# **Product Change Notification**

#### PCN-MI-514-2017

Business Unit	Product Line Code	Type of Change	Action	Date of Issue
MI - Marking and Installation	BG3	Product Change Notification	Notify Distributors and Field	4/12/2017

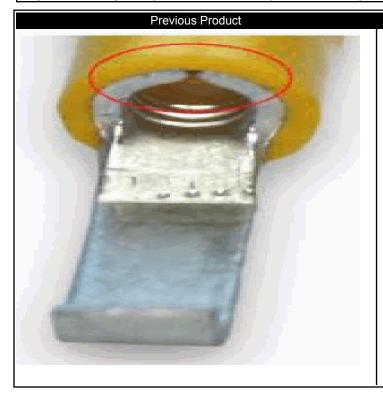
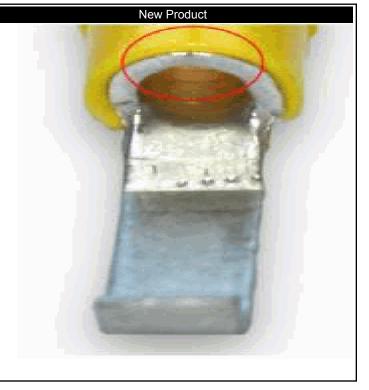
- 1. The items will be delivered in the future with a hard soldered seam see picture.
- 2. The connectors are also suitable for vertical crimping and can be especially used for USST ... terminal blocks now.
- 3. The items 3240057 C-BCI 6/2,8 SO [3240057] and C-BCI 6/4,6 SO [3240067] will be replaced by C-BCI 6/2,8 [3240047] and C-BCI 6/4,6 [3240570] without any technical change. This will take place on 1st October 2017. This means the affected item no. will be set inactive (IN) in SAP.
